FSD Circular Letter No. 6/2021

Standard for Fire Detection and Fire Alarm Systems for Buildings

TECHNICAL GUIDANCE

Application of BS 5839-1:2017 (Incorporating Corrigendum No. 1)

Figure A

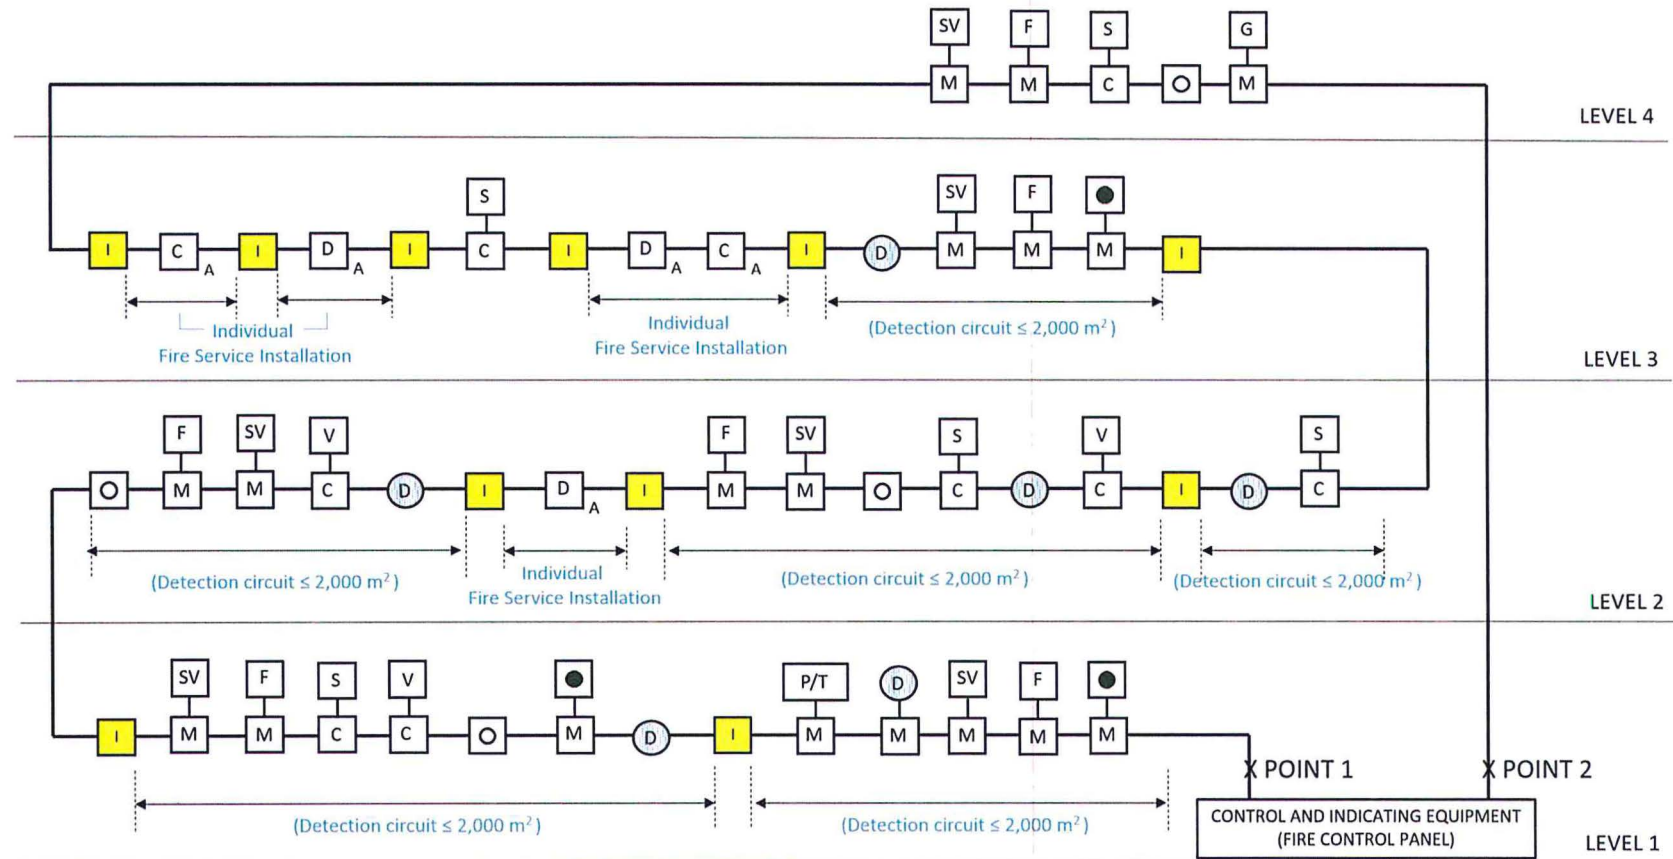
Clause 12.2.2 b) should be revised and read as

“A single short circuit or open circuit fault on an automatic fire detector and/or manual call point circuit should neither disable protection within an aggregate floor area of more than 2,000m² (calculated only on those portions of the premises installed with fire detectors), nor on more than one floor of a building.

NOTE: The above requirement does not apply to circuitries in non-addressable system.

For non-addressable system, a single short circuit or open circuit fault occurred in -

(i) manual call point circuit shall not disable protection on more than one floor of the building;

(ii) a detection circuit shall not disable protection within an aggregate floor area of more than 2,000 m² (calculated only on those portions of the premises installed with fire detectors) or on more than one floor of the building.”

Note: This clause is to clarify the calculation method of 2,000 m². (See Figure A – Circuit Arrangement For Automatic Fire Detection Circuit (Addressable System))

CASE 1 – Protected Area $\leq 2,000 \text{ m}^2$

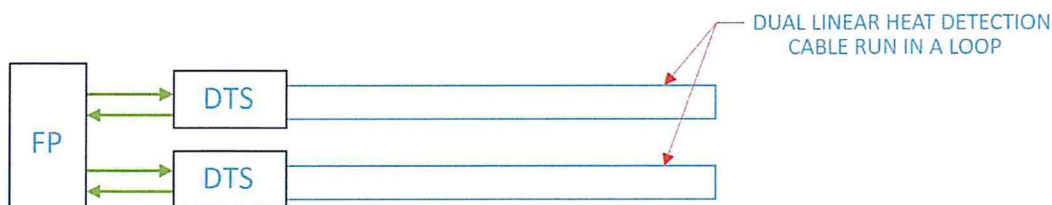
The following new Clause 12.2.2 m) should be added

- (i) For protection area not exceeding 2,000 m², a single short circuit or open circuit fault on the linear heat detection cable should not disable protection within the area of 2,000 m² by providing linear heat detection cable arrangement as shown in figure below.

Figure 1 – For Detectors inside Floor Voids

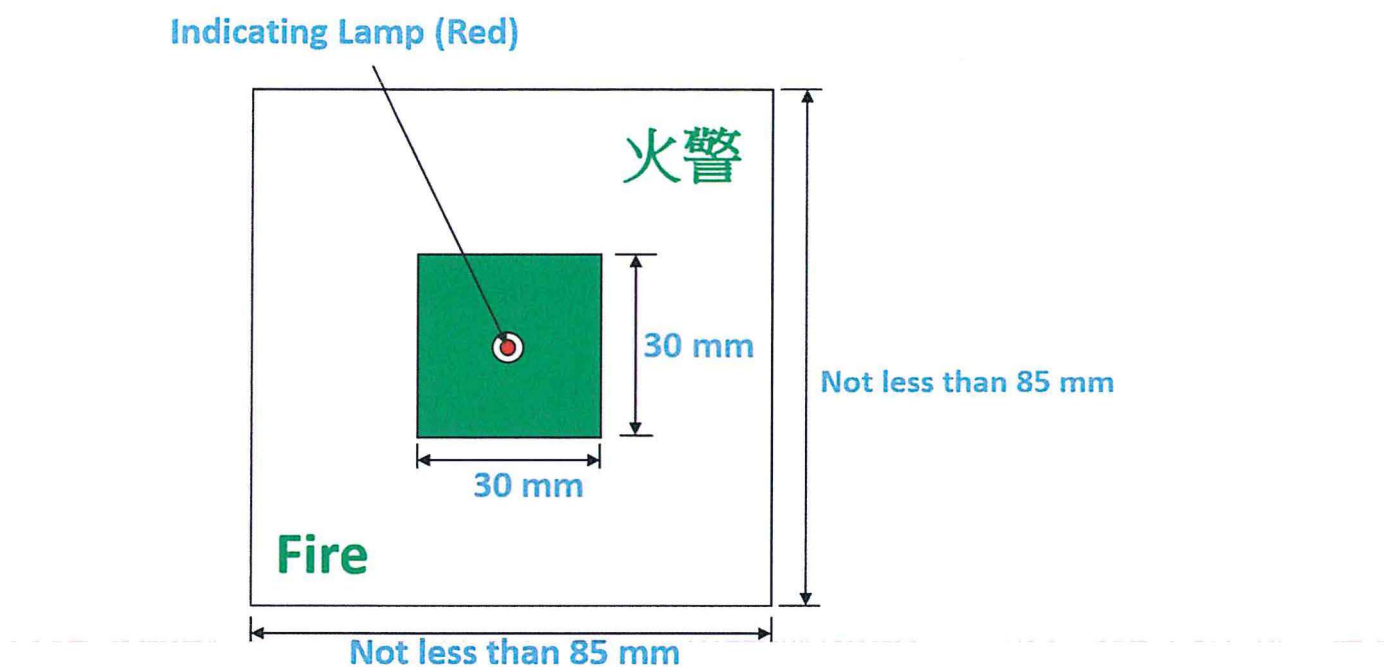
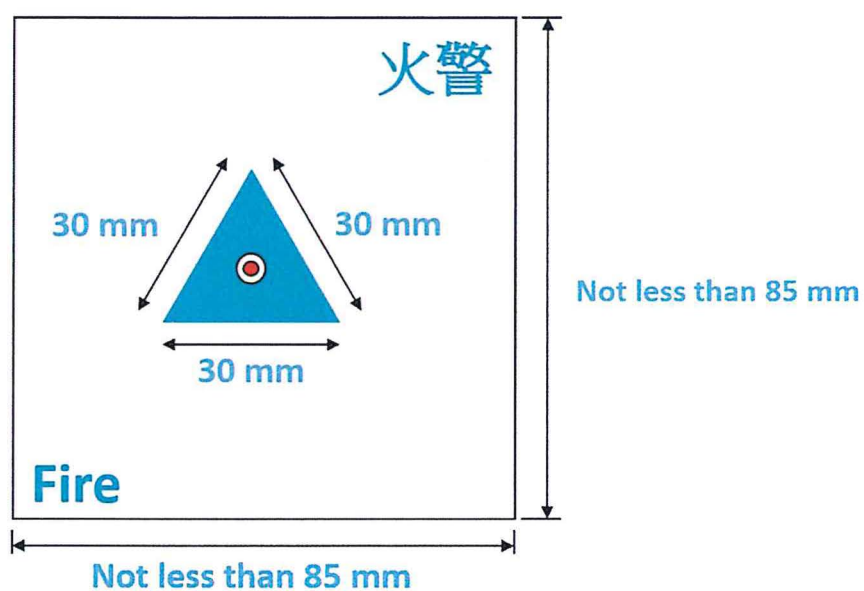
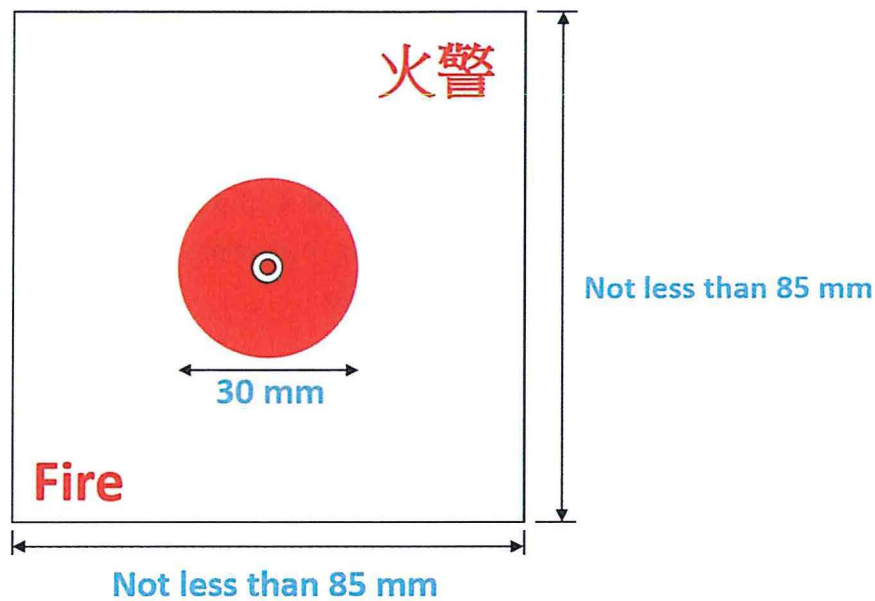
Clause 13.2.5 Para. 1 should be revised and read as

1. The colours for the plate, the graphic pattern and the wording should be suitably chosen so as to provide luminous contrast for the purpose of clear identification at a distance.
2. The indicating lamp should be red in colour.
3. The height of English letters and Chinese characters should not be less than 10 mm and 15 mm respectively or should follow the latest specifications issued by the Director of Fire Services from time to time.
4. The designs of remote indicating lamp plates for detectors in respective locations, i.e. floor voids, ceiling voids and lockable rooms, should follow the relevant graphic pattern illustrated below:-
 - (a) Figure 1 – For Detectors inside Floor Voids
 - (b) Figure 2 – For Detectors inside Ceiling Voids
 - (c) Figure 3 – For Detector inside Lockable Rooms”

Note: This clause is to meet local requirements for remote indicator labelling and clarify the requirement for the provision of remote indicator. For addressable system, remote indicator lamp is not required.

Figure 11 c) – Ceilings : Cells formed from joists [see 22.3k) and 22.3l)]

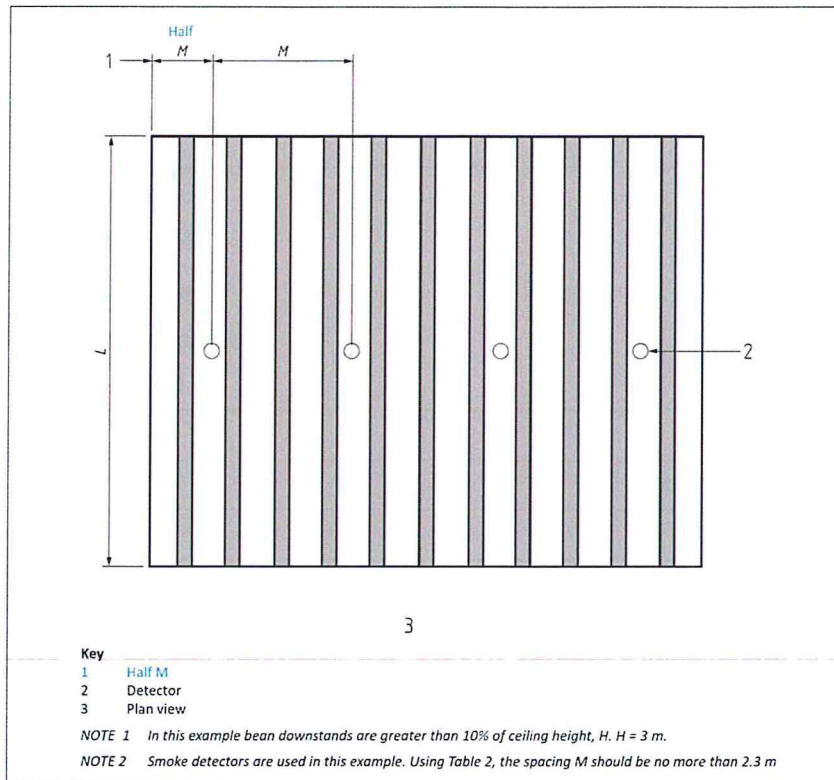
Figure 11 c) of Clause 22.3 l) should be revised and read as
